Subject: Public Comment for Chapters 5, Groundwater Conditions, of the draft Valley-Wide Integrated Groundwater Sustainability Plan and the 180-400 Foot Aquifer Subbasin GSP

Re: Chapter 5 of the 180-400 Foot Aquifer Subbasin Draft GSP and the Salinas Valley Basin Integrated Sustainability Plan Draft GSP

Subject: **Preliminary Comments Regarding Salinas Valley Basin Groundwater Sustainability Agency Draft Groundwater Sustainability Plan Chapter 5 (EKI B60094.03)**

Re: Comments on SVBGSA's draft Chapter 5 "Groundwater Conditions" of Salinas Valley Integrated Water Management Plan

Selected Figures from Gottschalk et al. Interpretation of Hydrostratigraphy and Water Quality from AEM Data Collected in the Northern Salinas Valley, CA, dated 15 March 2018.

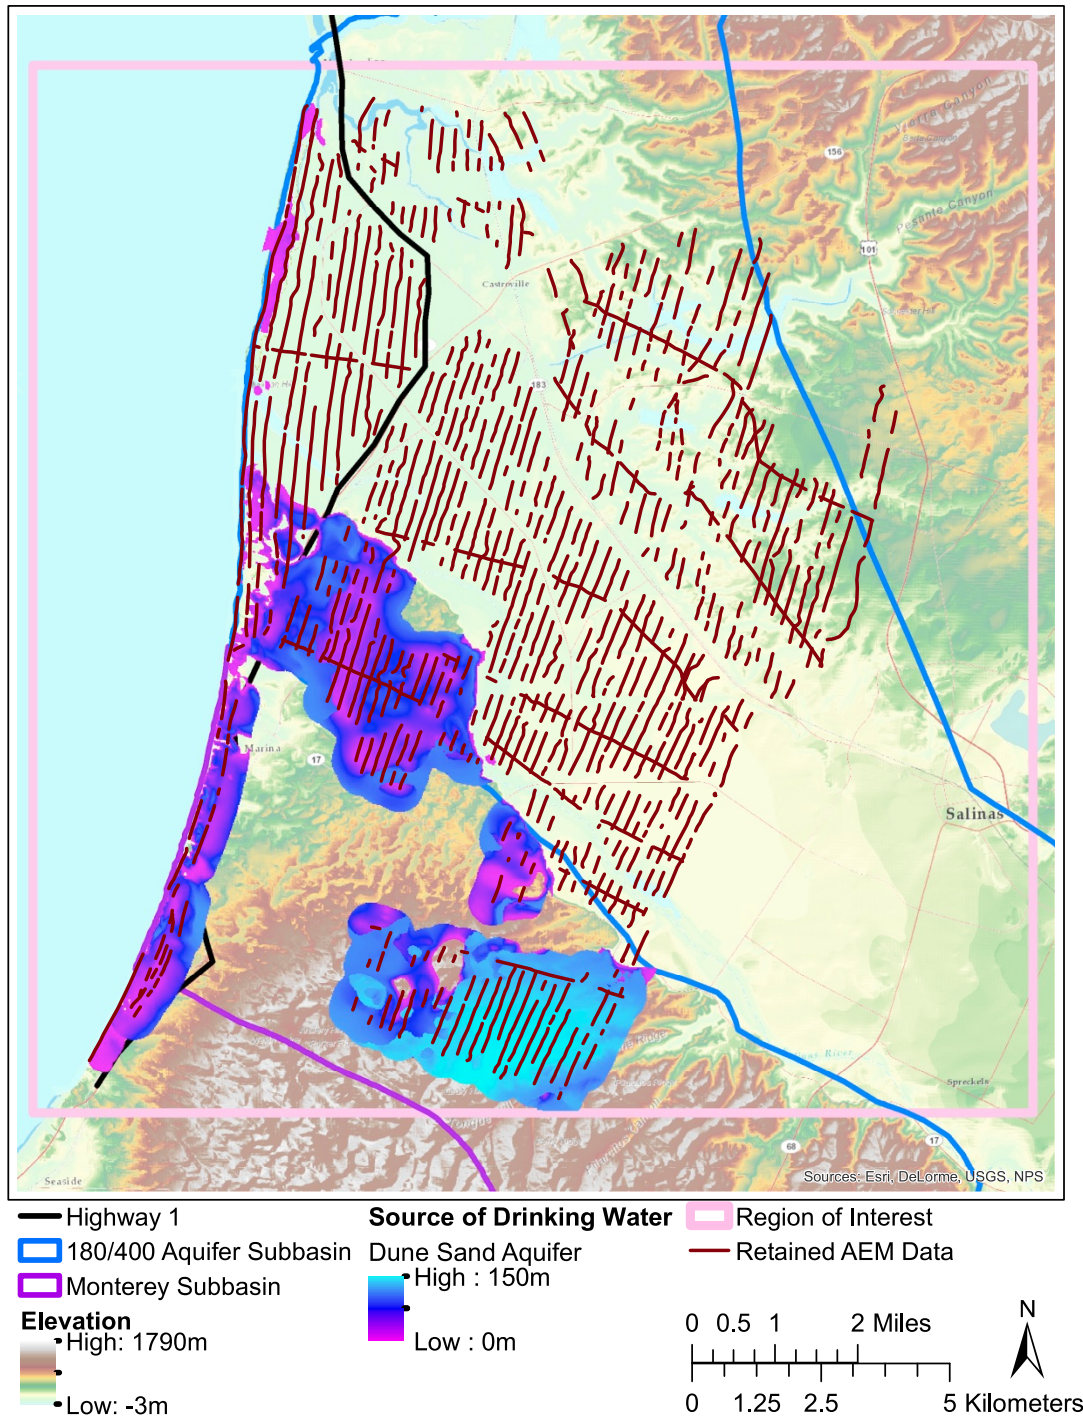
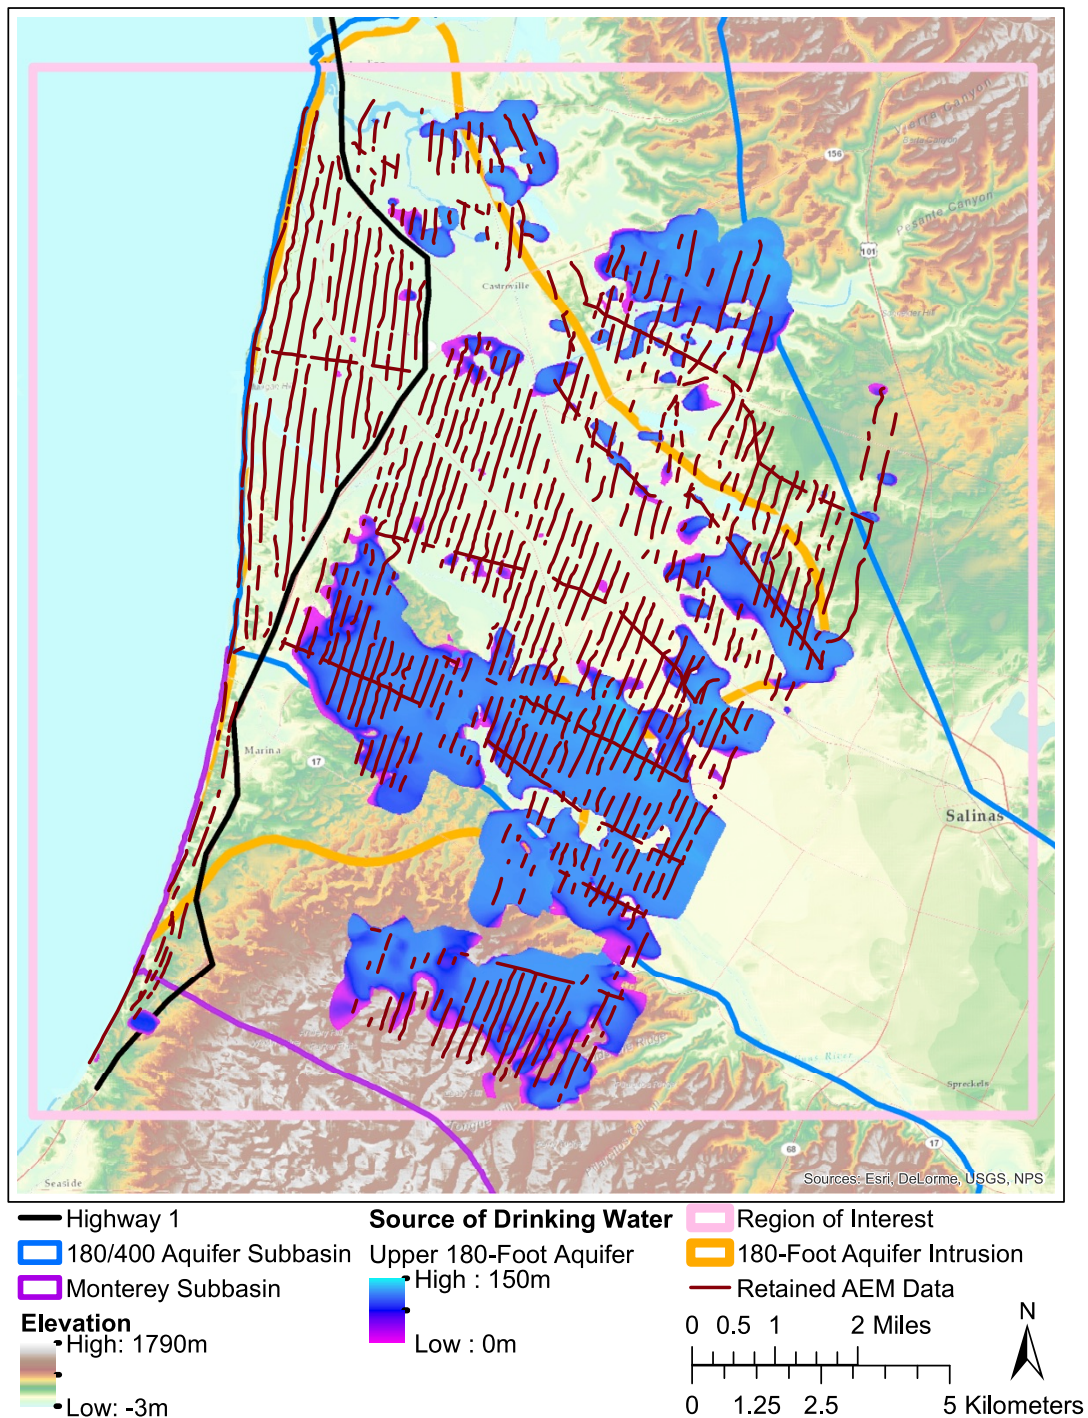
Per GSP Regulations Section 354.16 (c), a GSP should provide “seawater intrusion conditions in the basin, including maps and cross sections of the seawater intrusion front for each

principal aquifer”. The GSPs should address this requirement and provide cross-sections. AEM data collected by MCWD should be incorporated into these cross-sections¹.

Page 14, Figure 5-6, Figure 5-11 and Appendix 5A: hydrograph confidentiality.

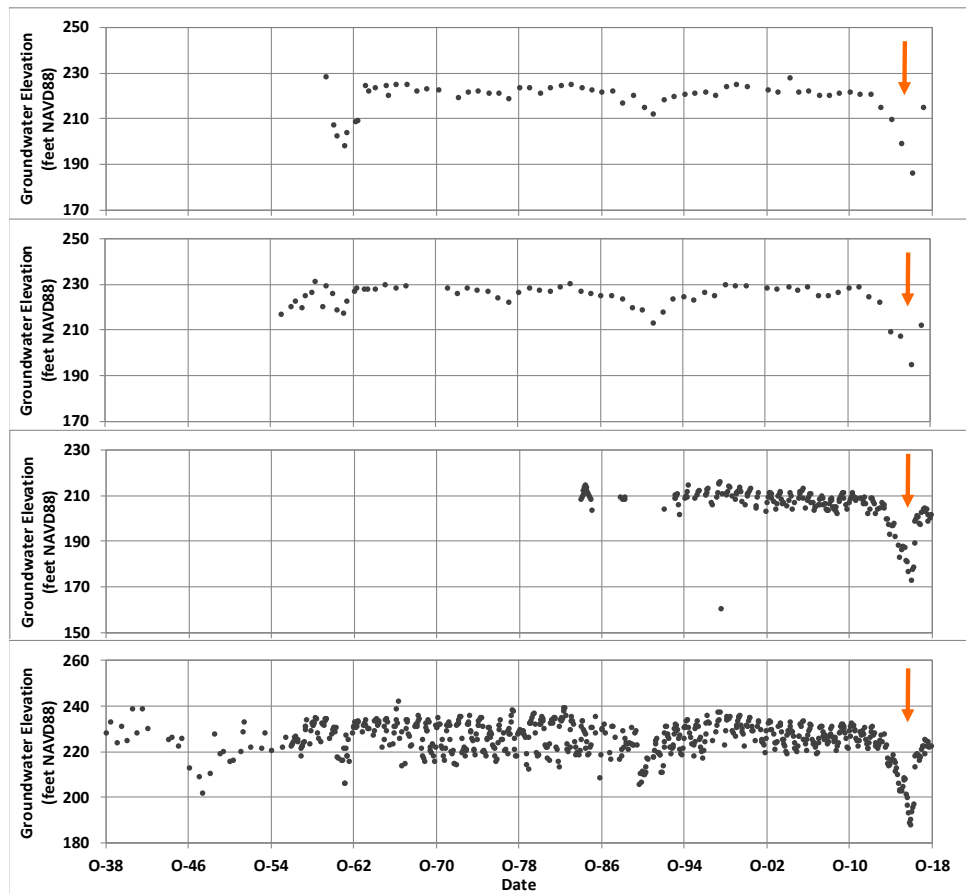
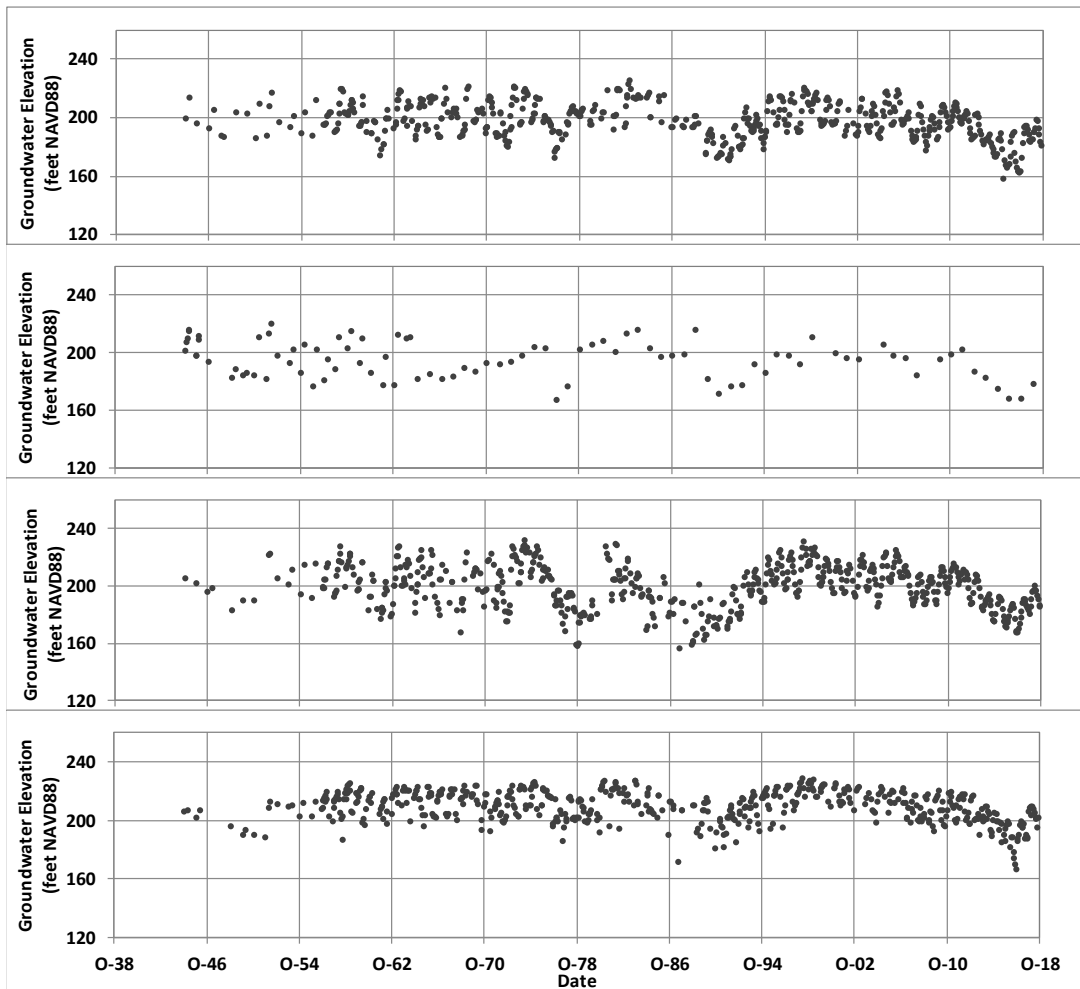
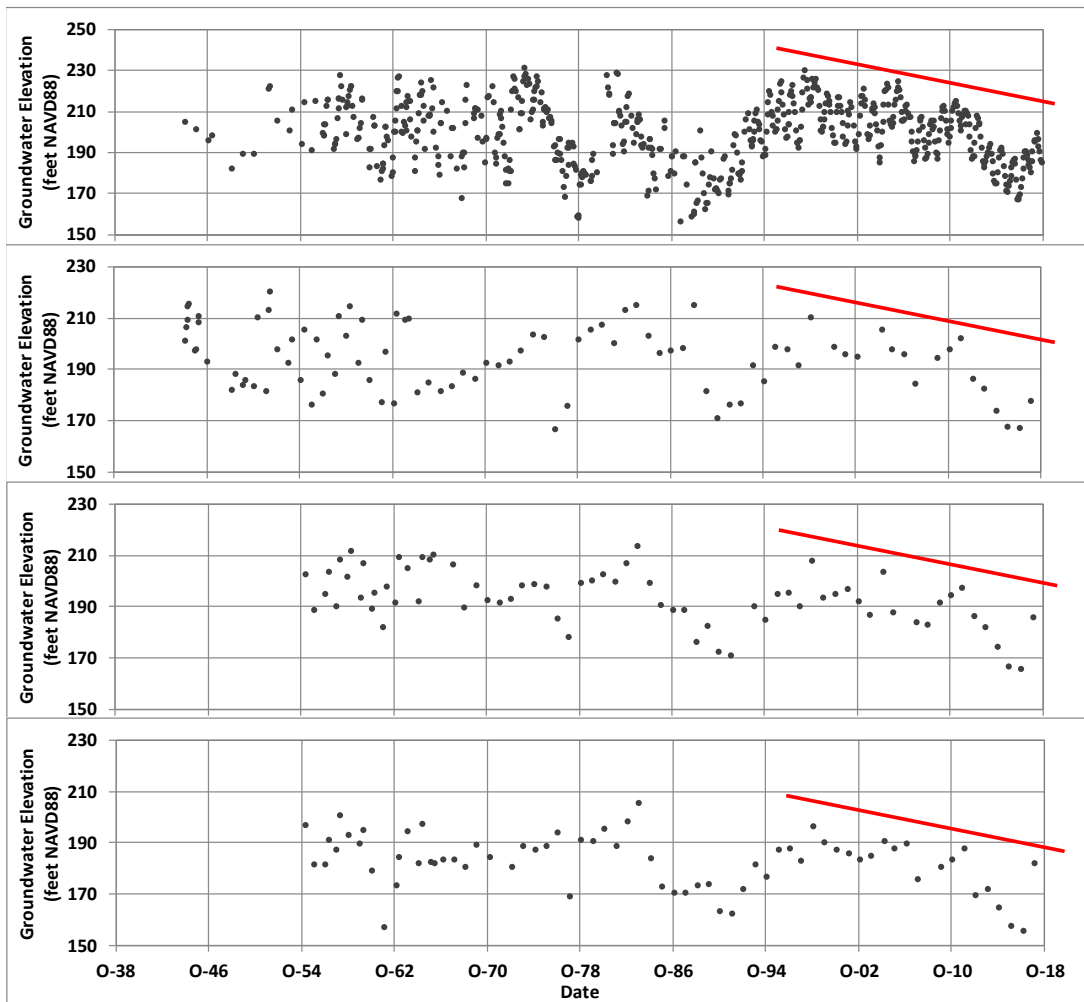
Confidentiality does not preclude presenting hydrographs in reports, provided the well is not exactly identified. By limiting the presentation of data and discussion to only eight wells (Figure 5-6) or 55 wells (Figure 5-11 and Appendix 5-A) out of the 760 locations where MCWRA has collected water levels is unnecessarily selective excluding the data. In particular, the Forebay and Upper Valley Subbasins are underrepresented in the figures and discussion. Groundwater conditions in the Forebay Subbasin cannot be represented by a single hydrograph, as Figure 5-6 implies. By selectively excluding the data, the report fails to identify and disclose local variations in hydrograph patterns that provide important understanding of the relative influence of various recharge sources and, hence, which variables are important for groundwater management. In general terms, the report does not provide adequate granularity of data analysis, and hence may not correctly reflect groundwater conditions in these subbasins.

Groundwater conditions in the Forebay Subbasin are not homogeneous, as the draft chapter implies. Wells close to the Salinas River have hydrographs with pronounced declines during 2013-2016, as illustrated by these four hydrographs:

In contrast, water levels in the following set of four wells higher up on the Arroyo Seco Cone show greater seasonal variability but little cumulative decline during 2013-2016:

Finally, several wells on the northwestern flank of the Arroyo Seco Cone have declining trends since 1990 that are probably related to intensified local pumping to supply new vineyards in the hills to the west where well yields are poor (see hydrographs, below).

These details matter. The broad brush presentation of water levels in the draft chapter conceals local variability that is relevant to sustainability and management actions.

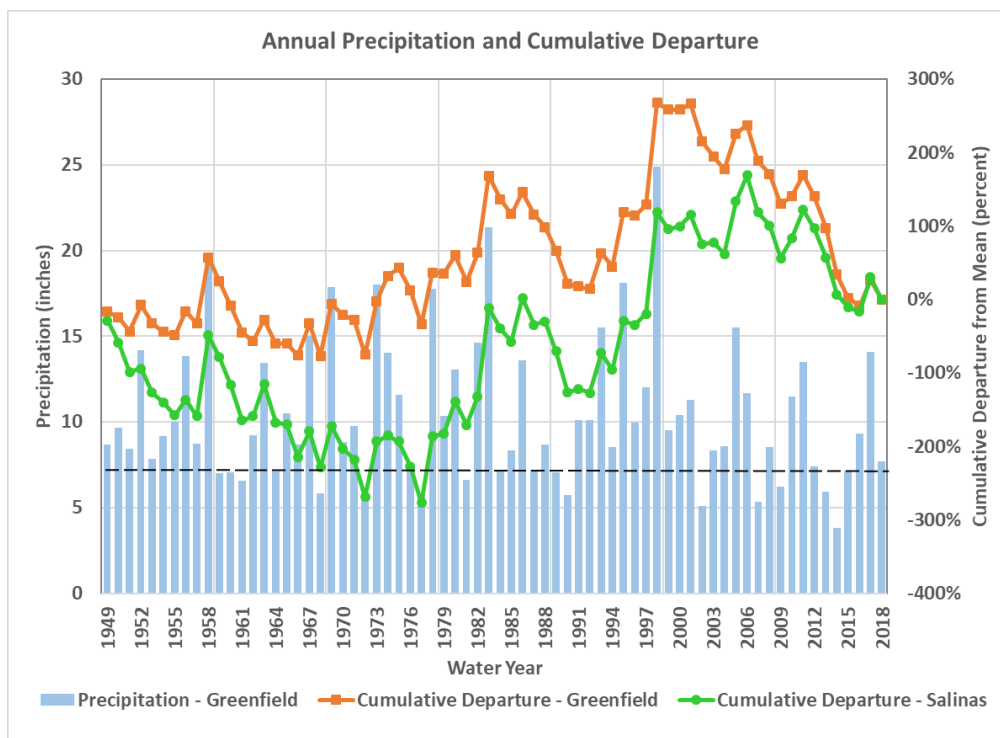
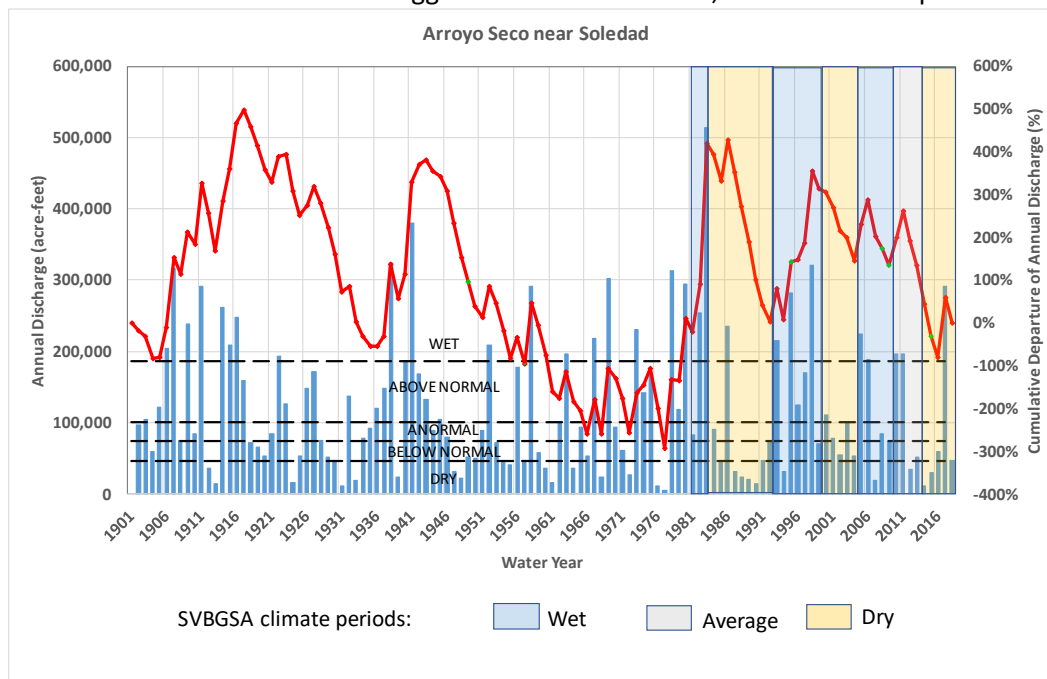
Page 21, 1st paragraph. Water year types. The water year types shown as background in Figures 5-7 through 5-10 are based on a Standardized Precipitation Index methodology that this report does not document but that is described in the 180/400 Foot Aquifer and Paso Robles Subbasin draft GSPs. The SPI method using a 5-year backward average of annual precipitation does not adequately represent wet and dry periods related to groundwater for two reasons. First, groundwater levels correlate more closely with runoff than with rainfall. The standard practice for hydrologic analysis in California is to identify wet and dry periods on the basis of cumulative departure plots. The SPI method is seldom, if ever, used. For example, cumulative departure of annual rainfall at Greenfield and Salinas are shown in the graph below. For both stations, missing data were filled by correlation with nearby gauges to ensure a complete record. Both stations show that the wet period culminating in 1998 was a larger event than the wet period culminating in 1983.

However, groundwater levels in almost all Forebay wells were higher in 1983 than in 1998. This suggests that recharge was greater during the earlier event. A cumulative departure of annual discharge in Arroyo Seco—which is unregulated—reveals that with respect to streamflow the 1983 event was bigger than the 1998 event, as shown in the plot below.

The stronger correlation between runoff and groundwater levels means that cumulative departure of annual Arroyo Seco discharge represents climatic periods better than cumulative departure of rainfall and should therefore be preferred for use in groundwater analysis and planning.

The second weakness of the SPI method is that the 5-year averaging method misses the correct starting and ending years of wet and dry periods. To illustrate, the wet, dry and average (or fluctuating) periods shown in Figures 5-7 through 5-10 of draft Chapter 5 are transcribed onto the cumulative departure of Arroyo Seco discharge, above. The 1984-1992 dry period starts two years too early (1987 was the first dry year of that drought). Similarly, the first two years and the last year of 1993-1999 were not wet. The wet period would more accurately be identified as 1995-1998. 2005 and 2006 were wet, but they did not amount to a large wet period. It might be more useful to simply classify 2005-2011 as variable. The Arroyo Seco cumulative departure plot shows the recent drought as comprised of 2012-2016. The SPI approach adds 2011 and omits 2014-2016 from that sequence, thereby significantly underrepresenting the actual duration and severity of dry conditions.

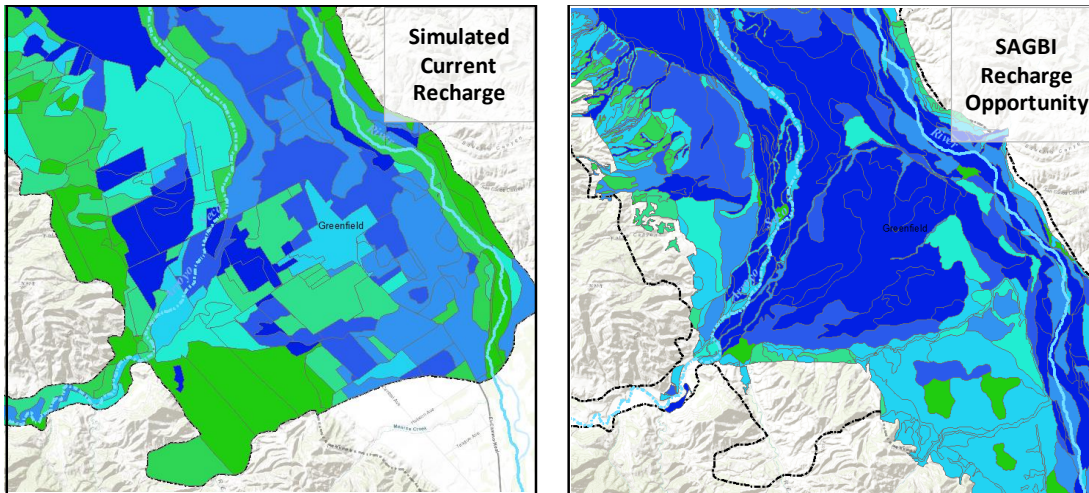
Locations of Recharge. GSPs are required to include maps of recharge locations, and such a map should also be included in the Valleywide Plan. Based on draft materials for the Paso Robles and 180/400 Foot Aquifer GSPs (prepared by the same consultant team), it is likely that the SAGBI map of recharge opportunity would be used for that purpose. However, the SAGBI map is not a map of where recharge currently occurs. It is a map of favorable locations for percolating water at high rates through the soil zone only. The two are not the same. Dispersed recharge through soils typically occurs at rates well below soil permeability and is determined more by the water balance of the root zone than by permeability. If infiltration of rainfall or applied irrigation water raise the water content in the root zone to above its storage capacity (root depth x available water capacity), then excess water will percolate downward and eventually reach the water table. Thus, dispersed recharge occurs wherever rainfall or irrigation occur, which is essentially the entire land surface overlying the Basin. The maps below compare current recharge in the southern part of the Forebay Subbasin simulated using a recharge-runoff-rainfall model (continuous, daily soil moisture budget simulation averaged over 1997-2008) with the SAGBI recharge opportunity map.

Both maps are color scaled so that green is low and dark blue is high. The simulation of current conditions shows the large differences between non-irrigated vegetation, truck crops, vineyards and urban areas. The SAGBI map reflects primarily soil characteristics. The two are very different.
